ADDENDUM NO. 2

August 7, 2026

Perry Township Schools:
Southport High School Addition & Renovation Phase 2 (Classroom Addition and Athletic Renovations)
971 E. Banta Road
Indianapolis, IN 46227

Phase 2: ADDENDUM NO. 2 (TWO)

TD102B

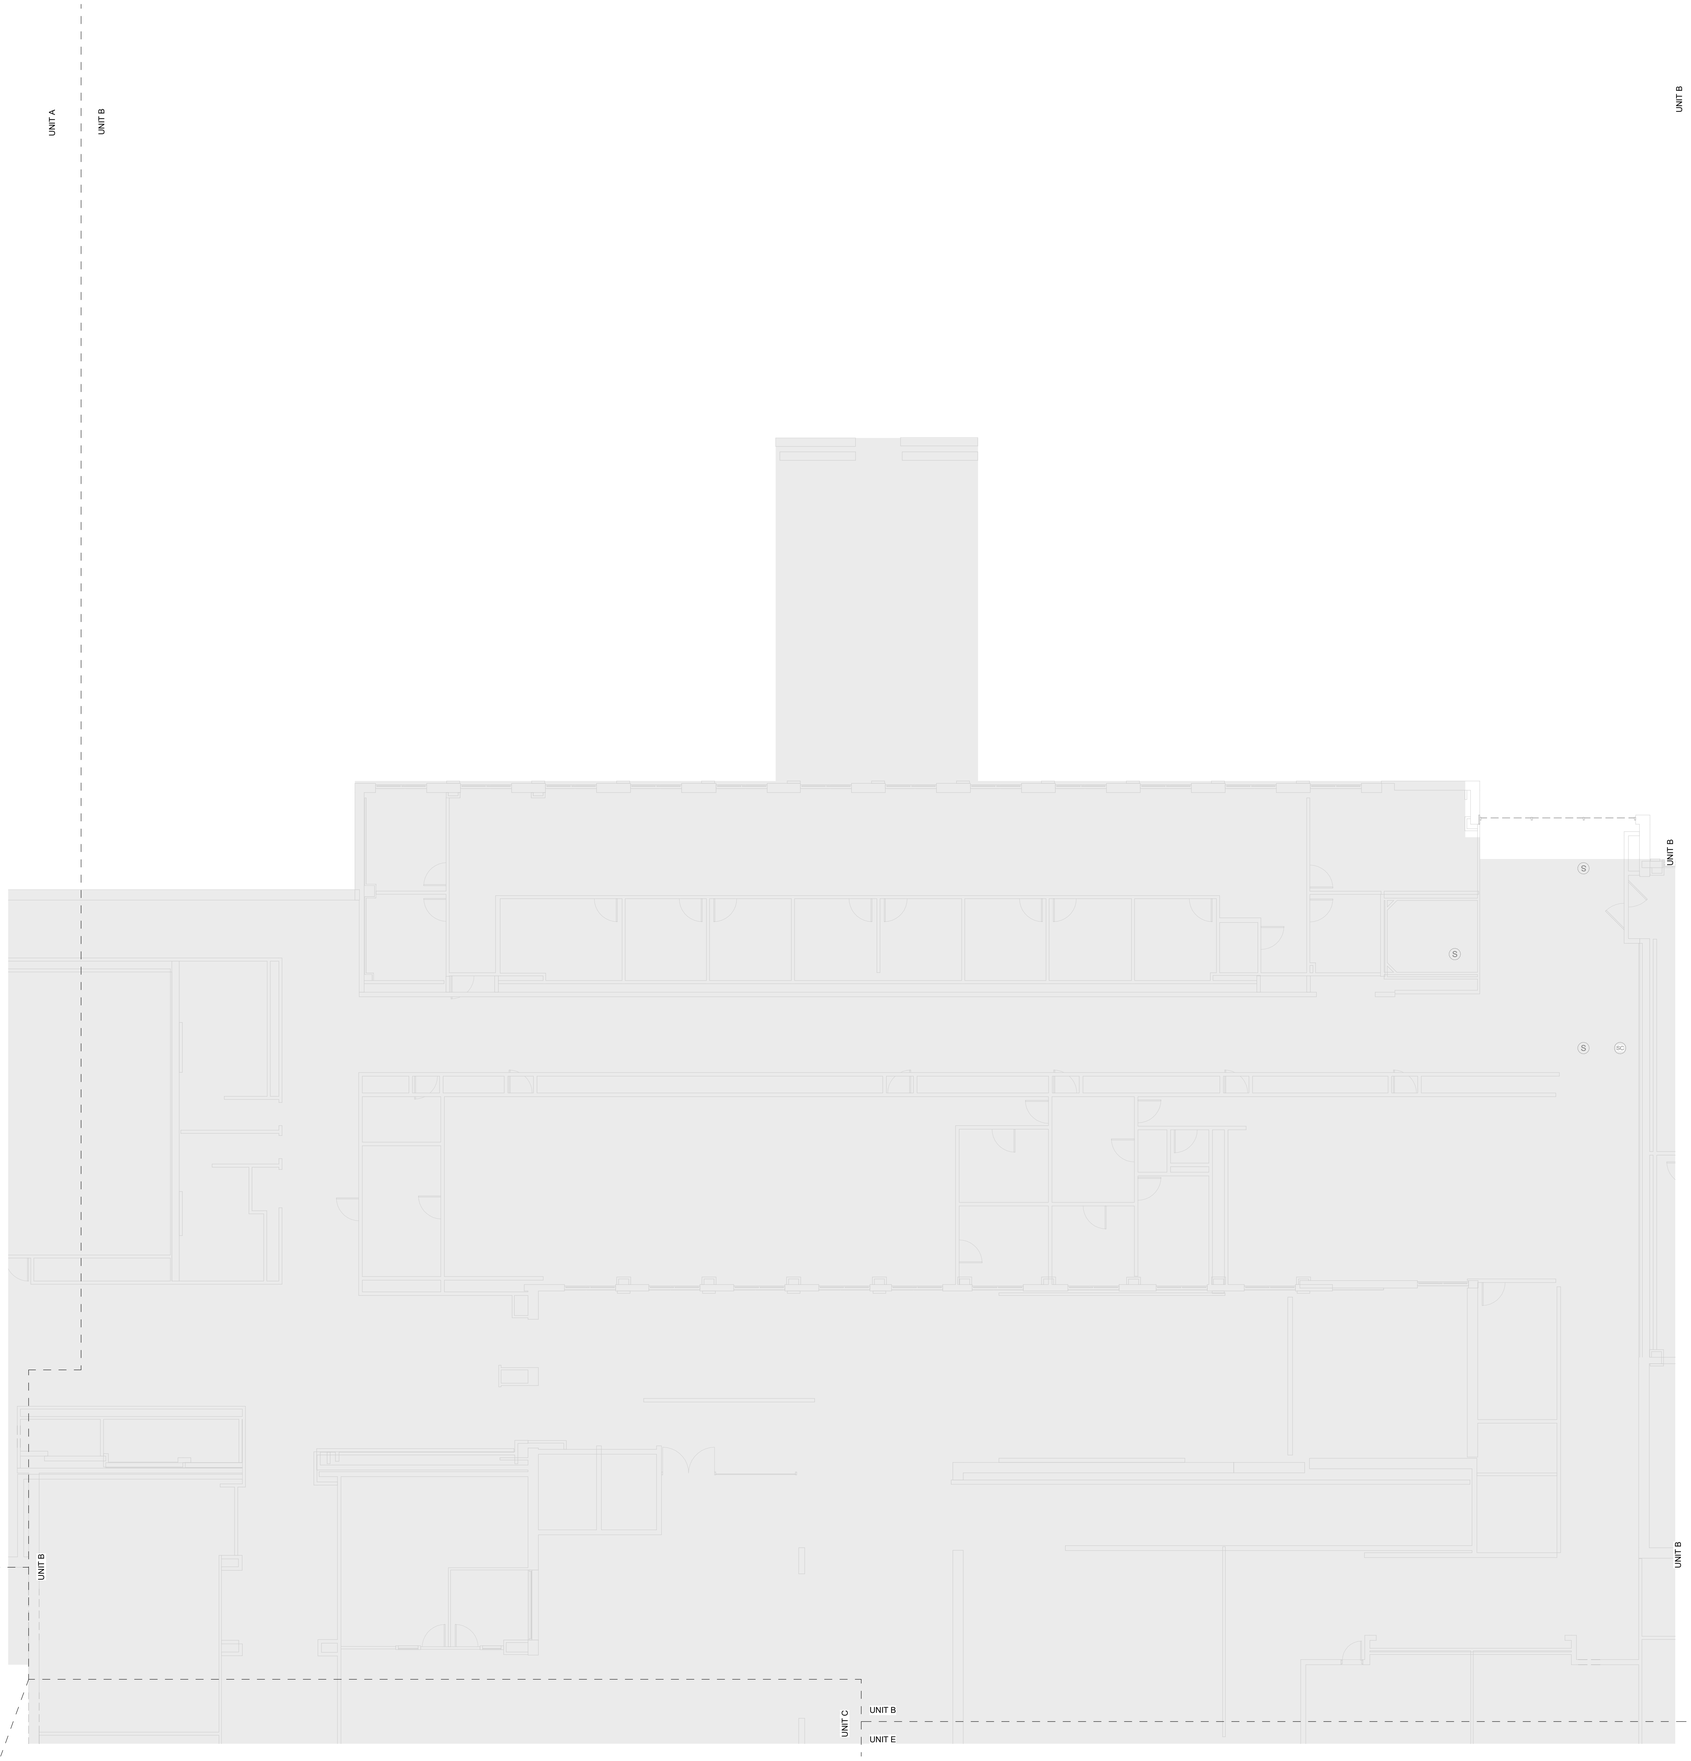
31. Drawing Number: TD102B
    Drawing Title: SECOND FLOOR DEMOLITION PLAN – UNIT B

Change: Removed unused sheet note block

SECOND FLOOR DEMOLITION PLAN - UNIT K

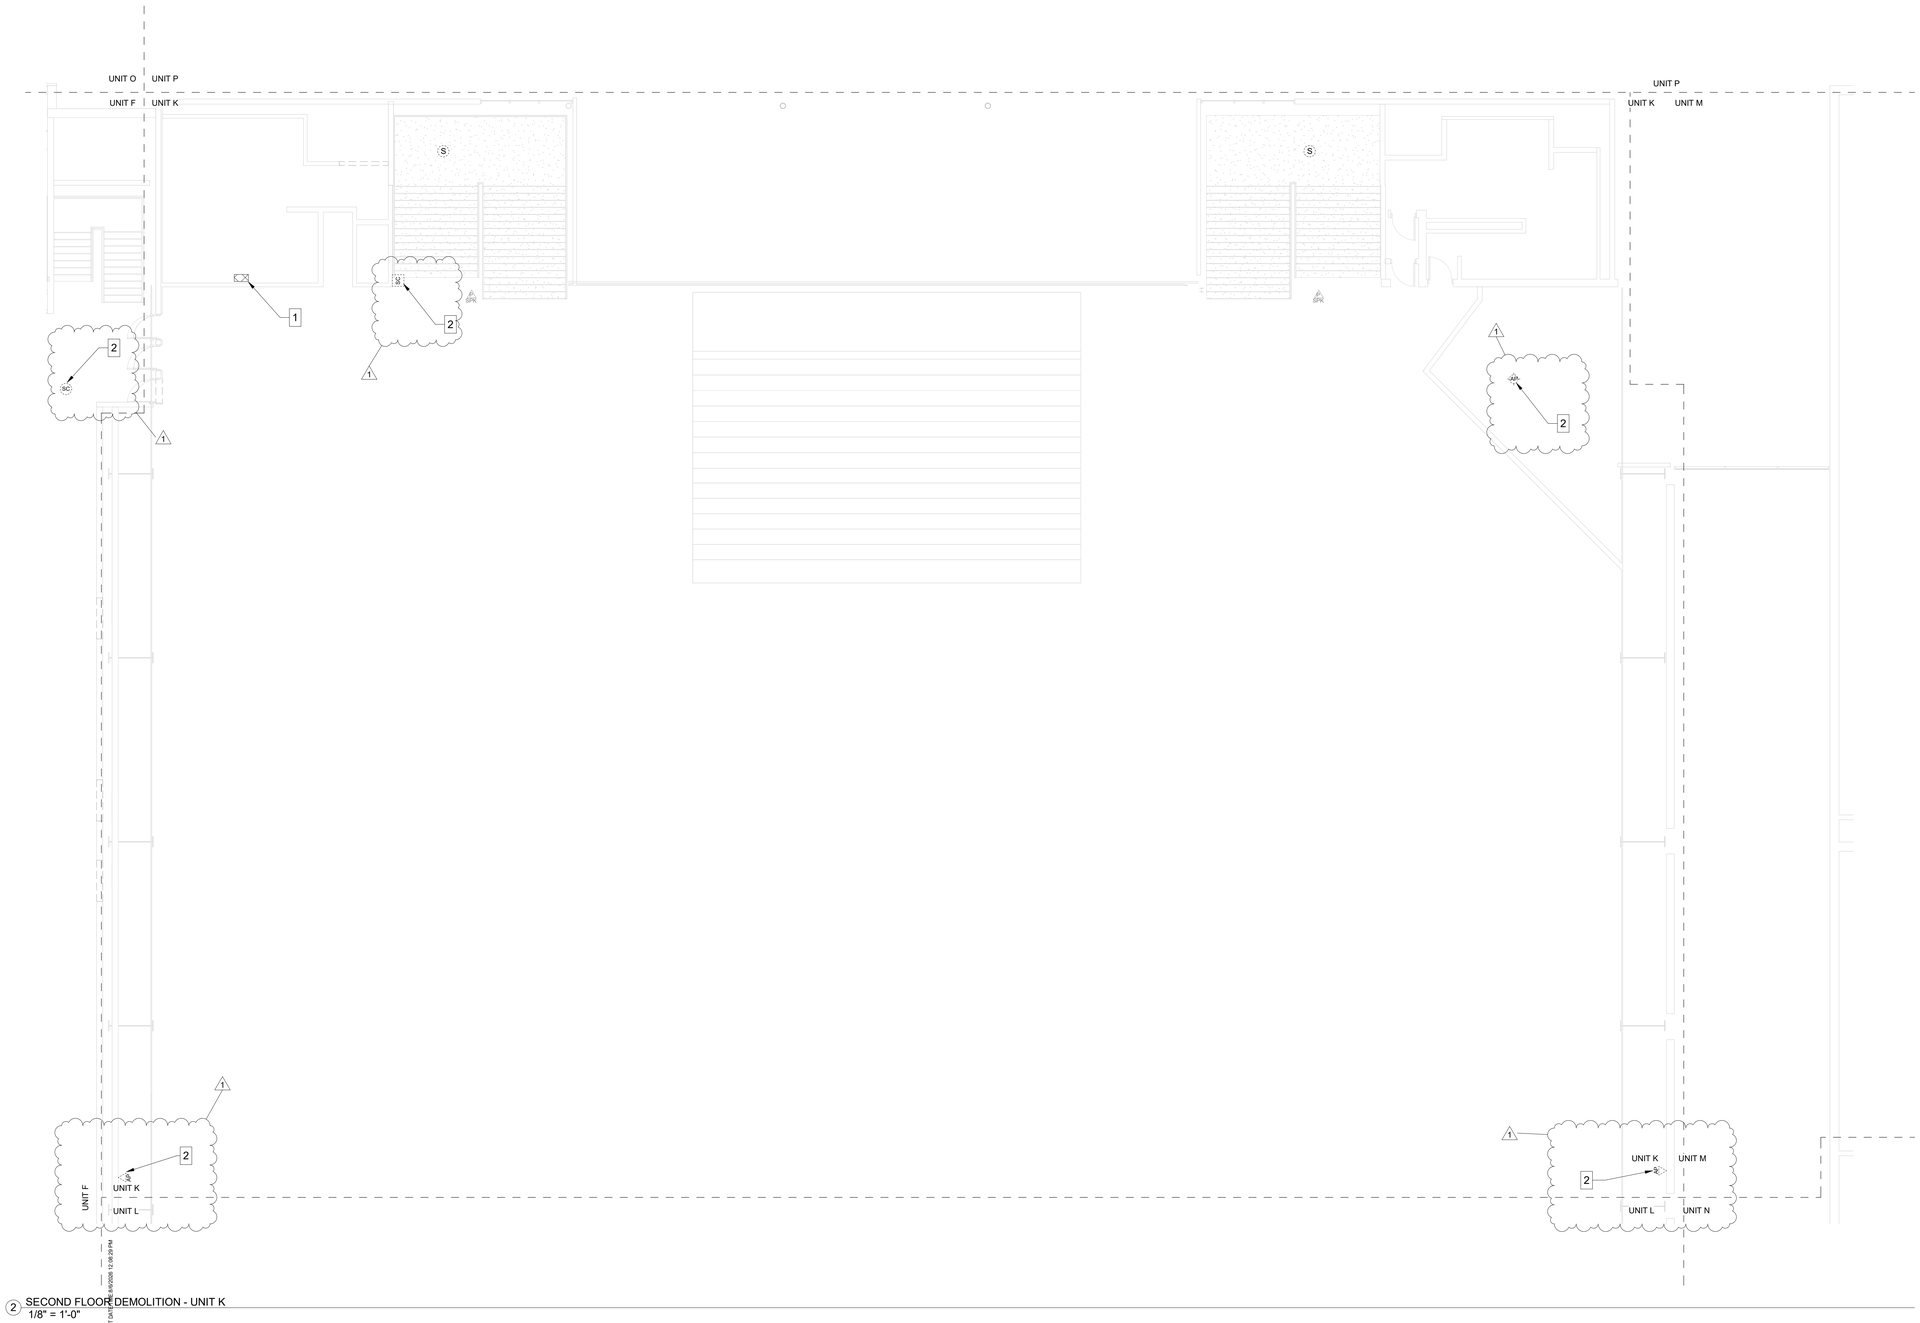
32. Drawing Number: TD102K
    Drawing Title: SECOND FLOOR DEMOLITION PLAN – UNIT K

Change: Added clarifying sheet notes for devices to remain and be recabled.
    - Added sheet note #2
    - Added sheet note #2 callouts to multiple locations on sheet

TD102L

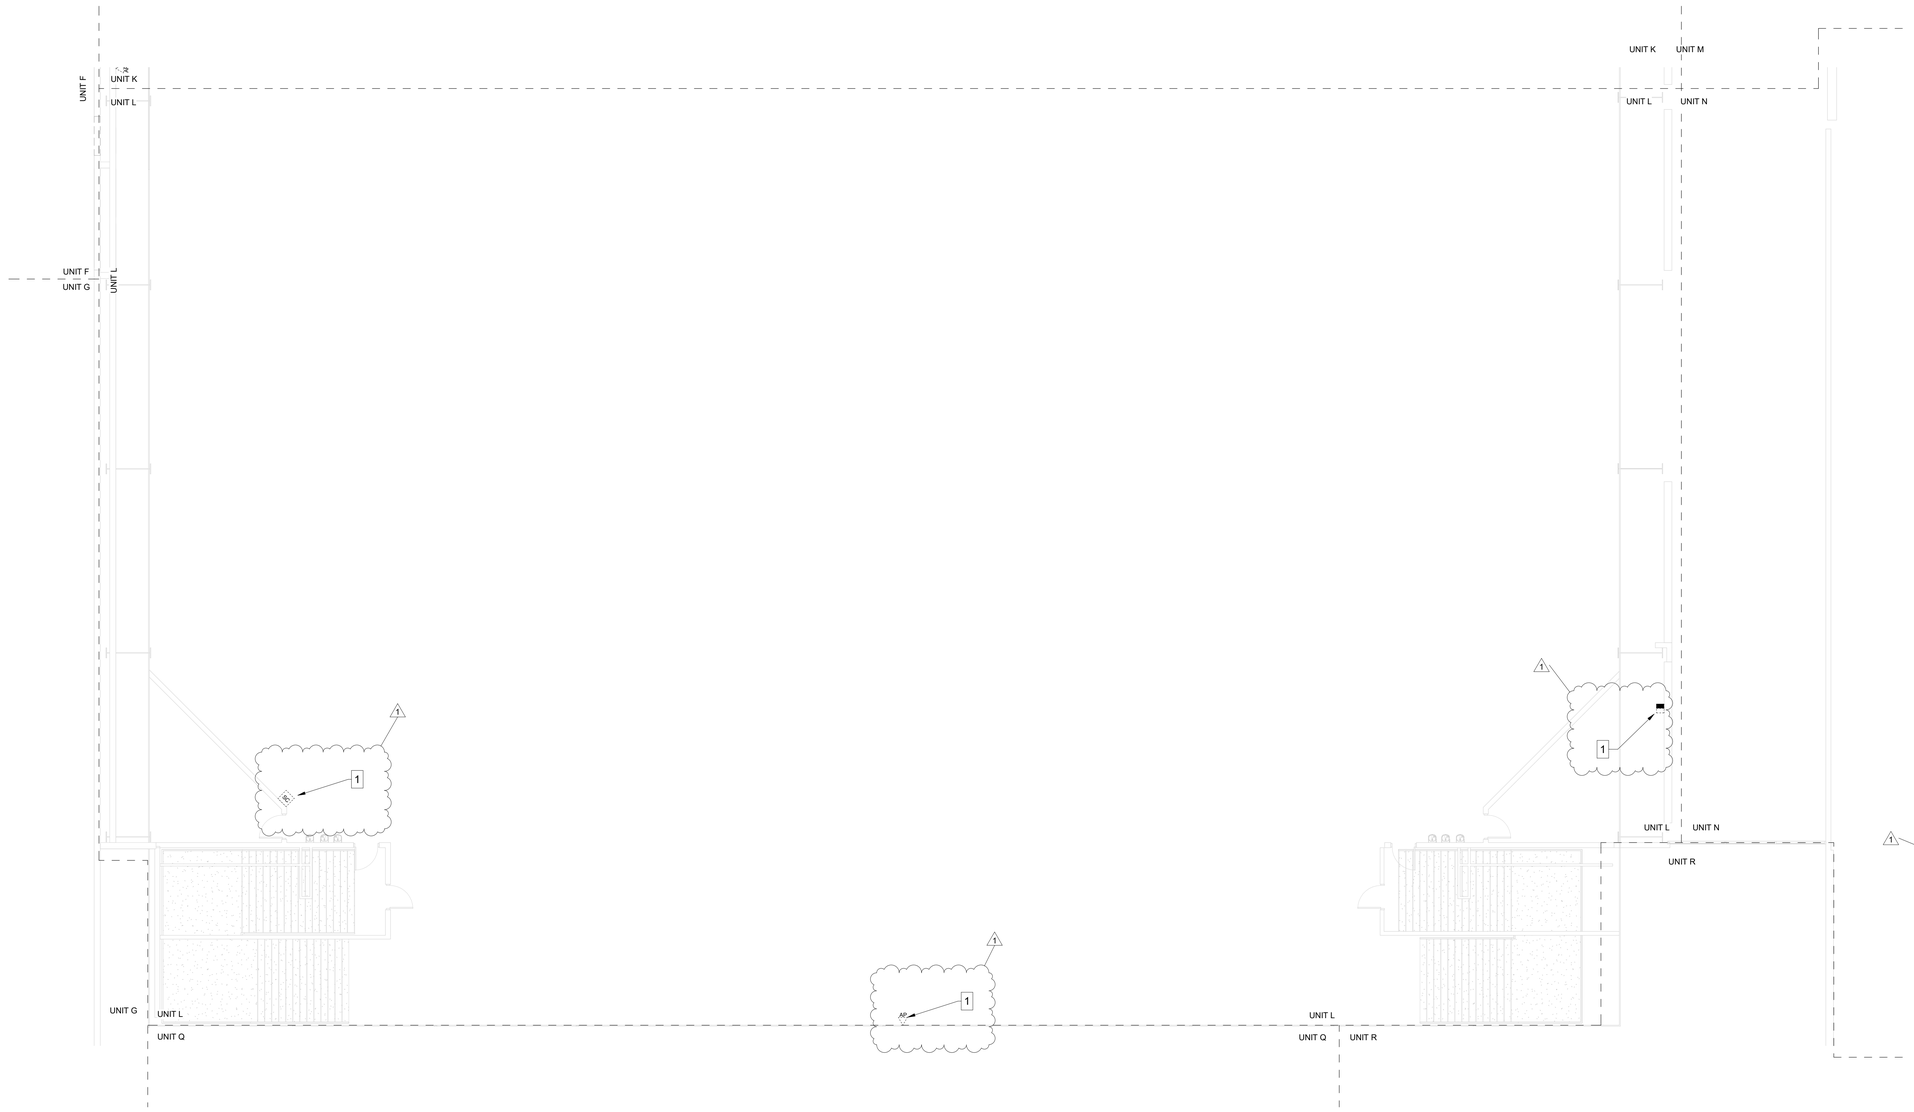
33. Drawing Number: TD102L
    Drawing Title: SECOND FLOOR DEMOLITION PLAN – UNIT L

Change: Added clarifying sheet notes for devices to remain and be recabled.
    - Added sheet note #1
    - Added sheet note #1 callouts to multiple locations on sheet

1 FIRST FLOOR DISTRIBUTION - UNIT K
1/8" = 1'-0"

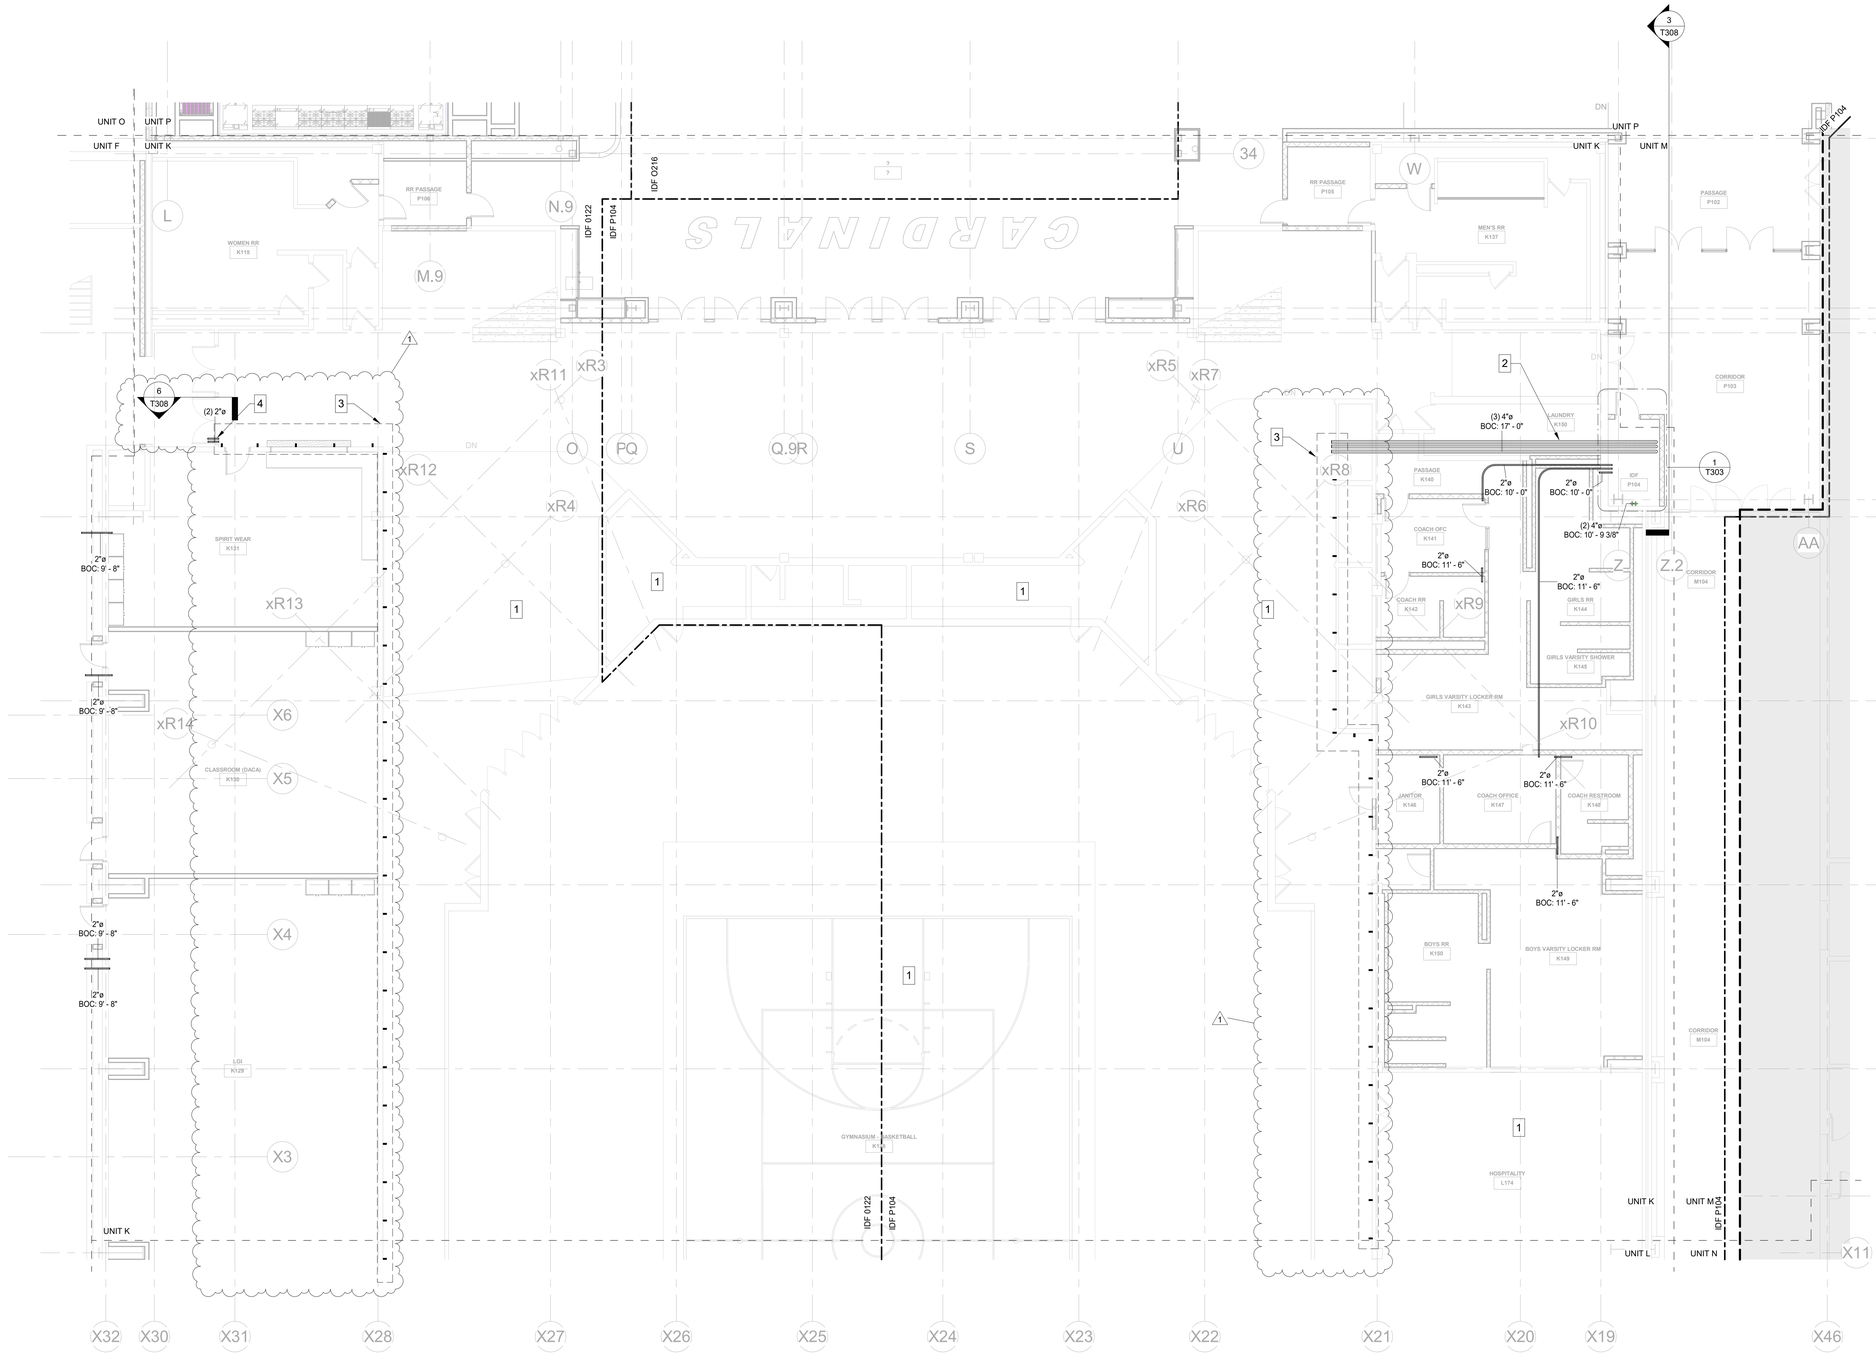
34. Drawing Number: T101K
    Drawing Title: FIRST FLOOR DISTRIBUTION PLAN – UNIT K

Change: Added scope
    - Added J Hooks in existing fieldhouse side corridors
    - Added sleeves from fieldhouse corridor to existing classroom corridor
    - Added section callout 6/T308
    - Added sheet notes #3 and #4
